Historic Landmarks and Preservation Districts Commission

Report to the Committee

Case No: 19-COA-0072 Classification: Committee Review

Property Address: 152 Vernon Avenue

Figure 1. 2003 District Designation Photograph of 152 Vernon Avenue.

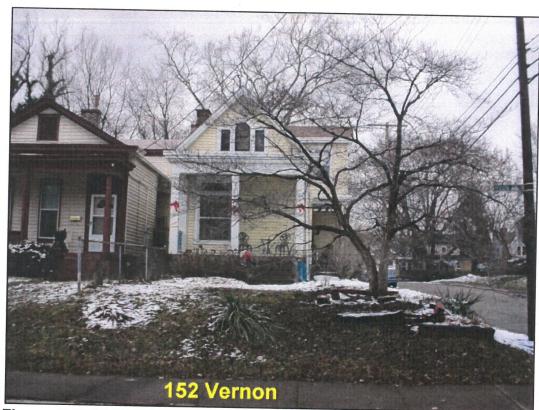
According to the 2003 district designation photograph, this shotgun did not have a front door on the front elevation. It had been previously removed and sided over. Thus, the proposed front door meets the Clifton design guidelines for **Door and Entrance**. However, the new door shall have door trim that matches the window trim to the south.

- 1. The new door shall have door trim that matches the window trim to the south.
- 2. The new addition shall be setback 15'-20' from the front of the building.
- 3. If the design changes, the applicant and/or their representative shall contact staff for review and approval.
- 4. The applicant and/or their representative shall obtain a building permit.
